Oil Filter Housing
D13H, D13J
VAH, VHD, VN

FSB 222-004, Oil Filter Housing

(June 2015)

W2059284

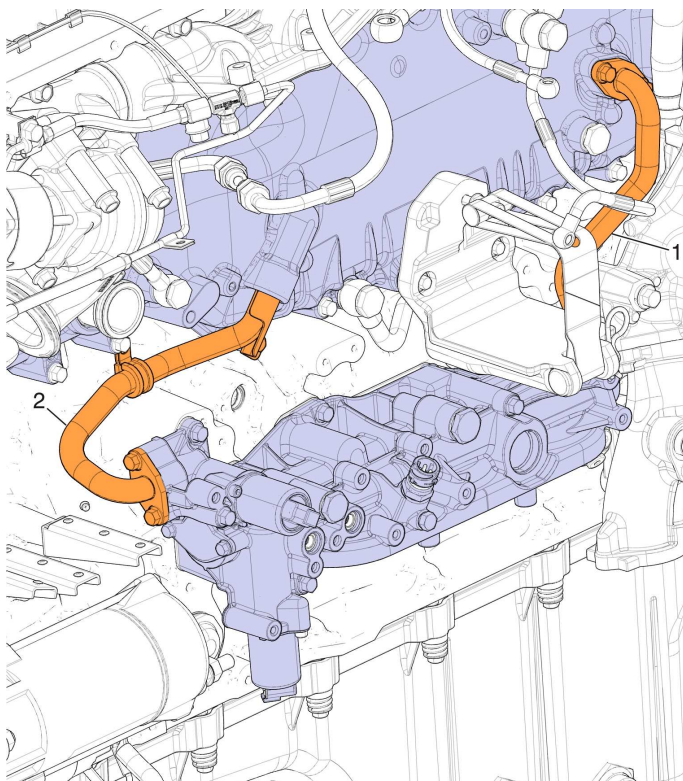
The introduction of a new style oil filter housing requires replacement of the oil cooler inlet pipe when replacing the previous style housing on US2010 and US2014 emission VOLVO D13 engines. Installation procedures remain the same, refer to Function Group 22 in Impact for proper installation. The updated oil filter housing is expected to go into production September 2015.
